SUBJECT: ADDENDUM TO THE DETERMINATION OF THE SUITABILITY OF SEDIMENTS PROPOSED TO BE MAINTENANCED DREDGED FROM TOKE POINT ENTRANCE CHANNEL AND TOKELAND MARINA, WILLAPA BAY (NWS-2008-164-DO) FOR OPEN-WATER UNCONFINED DISPOSAL USING FLOW-LANE DISPOSAL IN WILLAPA BAY AS EVALUATED UNDER SECTION 404 OF THE CLEAN WATER ACT.

1. The purpose of this addendum to the 24 January 2007 suitability determination (SDM: http://www.nws.usace.army.mil/PublicMenu/documents/DMMO/Tokepoint_Entrance-Tokeland_marina-sdm.pdf) is to increase the maintenance dredging volume from 62,846 cy to 65,000 cy, and to authorize the disposal of the suitable material proposed to be dredged by hydraulic suction dredge, with pipeline discharge of the finer grained sediments by “flow lane” disposal, and evaluate the suitability for placement of the coarser sediments on the beach adjacent to the marina as shown in **Figures 1** (vicinity map) and **2**. This change to the initial SDM reflects the consensus determination of the Agencies that comprise the regional Dredged Material Management Program (DMMP) for the State of Washington. The agencies include the Corps of Engineers, Department of Ecology, Department of Natural

Figure 1

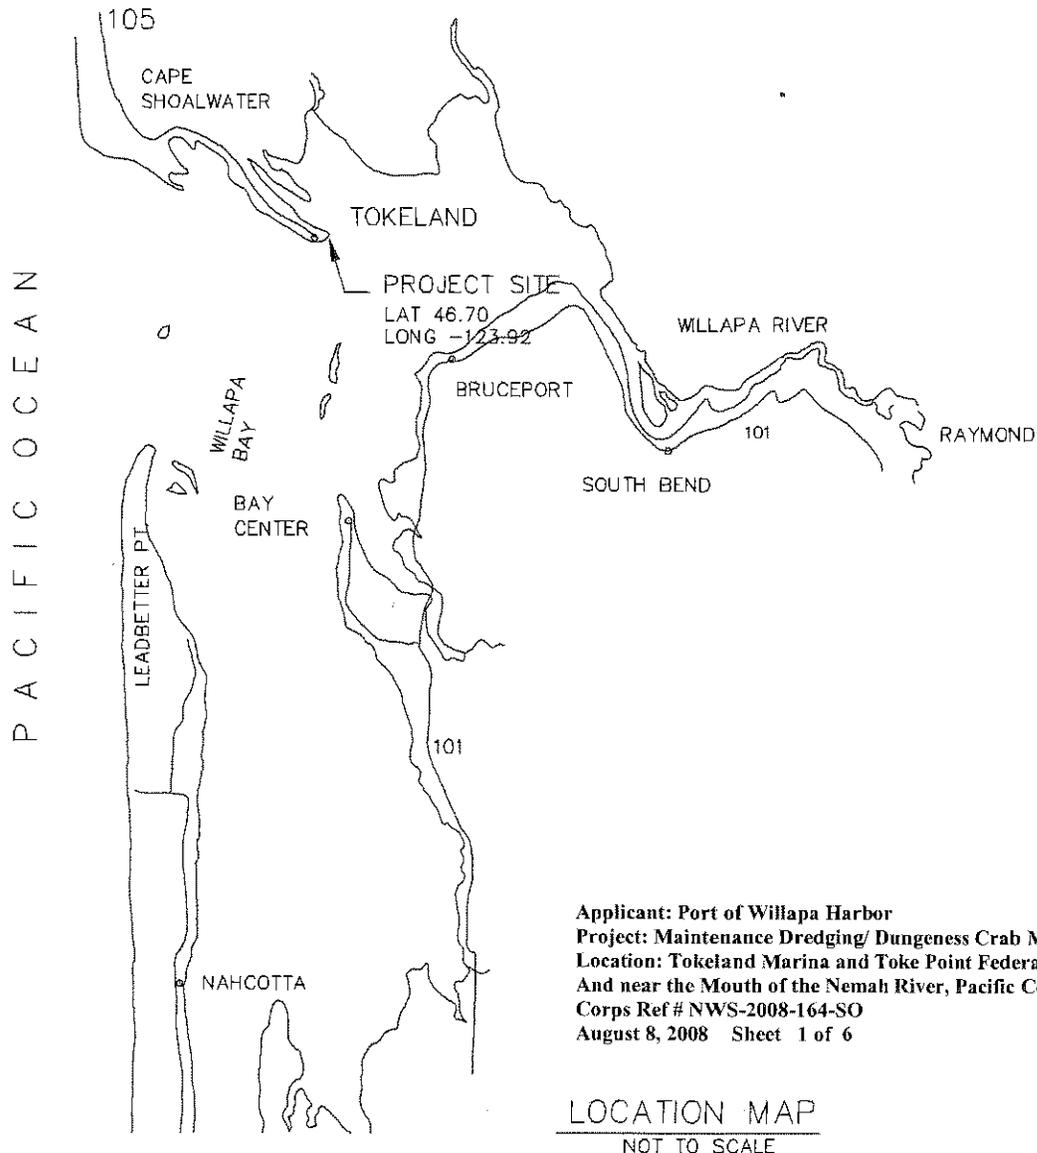
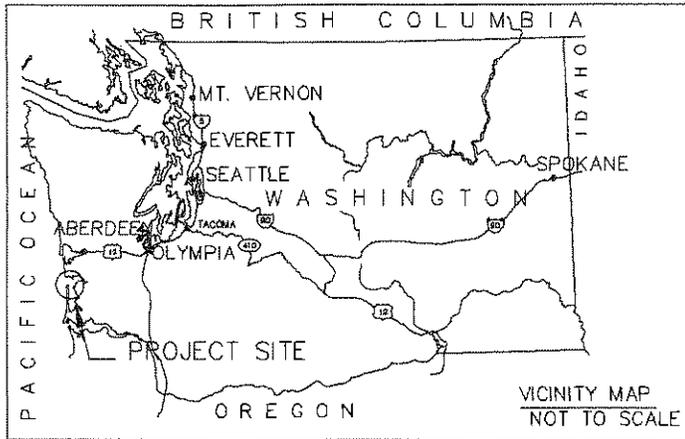
5. The testing data evaluated in 24 January SDM authorized beneficial use of all the material at an appropriate beneficial use site at Cape Shoalwater, and the proposed beneficial use site for the coarser sandy material has now been moved to the beach adjacent to the marina, as depicted in **Figure 2**. A letter of support for this beneficial use alternative from the Shoalwater Bay Indian Tribe is provided as **Attachment 2**. The DMMP agencies approve the location change adjacent to the Marina as an appropriate beneficial use.
